## BCA ASSESSMENT REPORT – DA SUBMISSION R1

<b>To:</b>	Nordon Jago Architects	<b>Project:</b>	24033
<b>Attention:</b>	Graham Jago	<b>Date:</b>	18.12.2024
<b>Subject:</b>	119 Goldsmith Street, Goulburn

STAC Consulting (NSW) Pty Ltd (STACC) have been engaged by Nordon Jago to carry out a review of the proposed single storey building which is proposing a change of use from a dwelling house to a medical consulting rooms with associated carparking and ancillary external works.

Figure 1: External walls on Western, Northern and Southern elevation located less than 3m from allotment boundary required to achieve an FRL of 60/60/60.

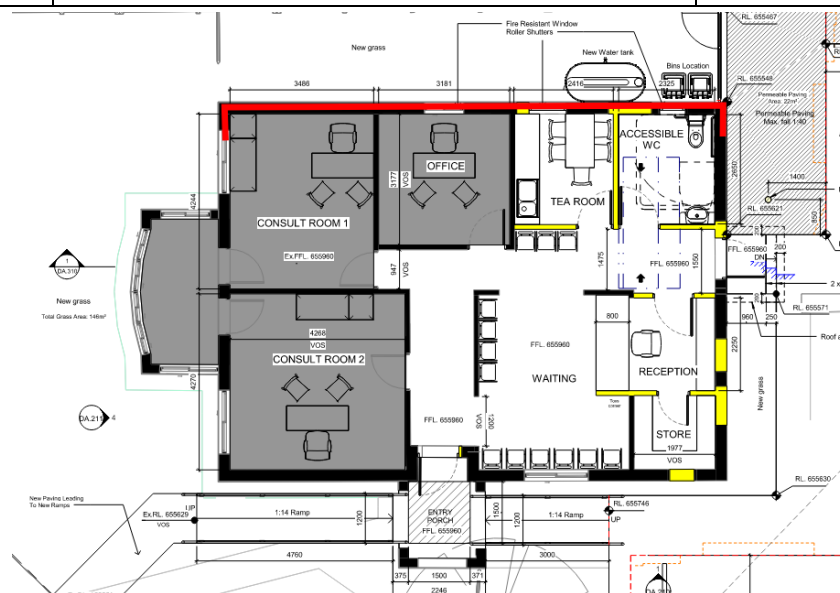
<b>S5C24 Type C Construction</b>	<ul style="list-style-type: none"> <li>• Building elements shall have prescribed FRLs as listed in Tables S5C24a, S5C24b, S5C24c, S5C24d and S5C24e and any beam or column incorporated in it, must have an FRL not less than that listed in those Tables for the particular Class of building concerned.</li> <li>• An external wall that is required by Table S5C24a to have an FRL need only be tested from the outside to satisfy the requirement</li> </ul>	<b>Compliance Readily Achievable / Further Detail Required at CC Stage</b> It is noted the external wall on the Western side and parts of the North and South external walls, are within 3m of the side allotment boundary (1.5m-

to less than 3m). In this regard, the existing and new parts of the walls must achieve an FRL of 60/60/60 (red line below). Refer Figure 1 below. Details to be provided at CC stage.
--	--	---
